Newmar Corporation

Technical Service Bulletin

Date Issued	Model Year(s) Affected	TSB #
11/09/2015	2010, 2012, 2013	429

Recall Service Bulletin

FIG. 3-1

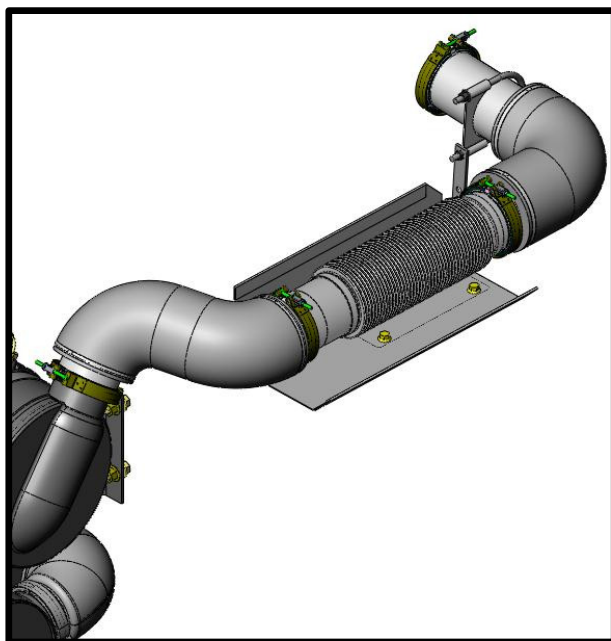
7. After completing alignment checks for the bellows/mating exhaust tubes and exhaust bellows has been removed: If alignment passes checks proceed to **step #9**. If alignment failed checks move to **step #8**.
8. Loosen clamps, support brackets, and v-band clamps that secure tubes to allow for adjustment of the tubes. Refer to 7th digit in VIN number for engine identification. If 7th digit is D, engine is an ISL: refer to FIG. 3-1. If 7th digit is E, engine is an ISX: refer to FIG. 3-2.

9. Install supplied bellows using supplied v-band clamps and gaskets. Leave clamps loose enough to allow for adjustment if required.
10. Using a straight edge, align tubes and exhaust bellows so they meet requirements for both angularity and lateral offset. The alignment must be checked in (2) two quadrants that are 90° apart. If **step #8** was skipped and proper alignment cannot be achieved **step #8** will need to be completed. Refer to FIG. 4-1.

FIG. 4-1

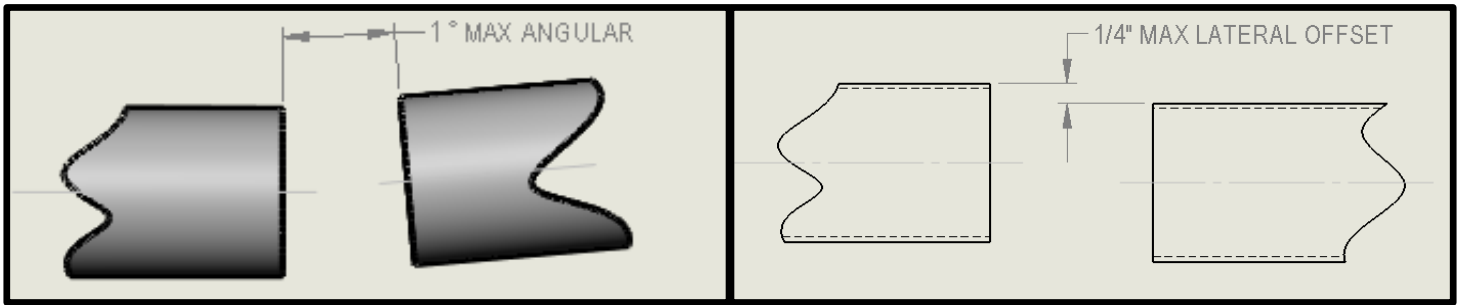
Alignment of the tubes and bellows are critical.

11. Once alignment requirements are met secure all clamps and brackets.
12. Torque (4) v-band clamps to 90 lbs. in.
13. Ensure all other hardware has been tightened.
14. Recheck alignment to ensure no shifting has occurred.
15. Reinstall retained heat shields (if required).
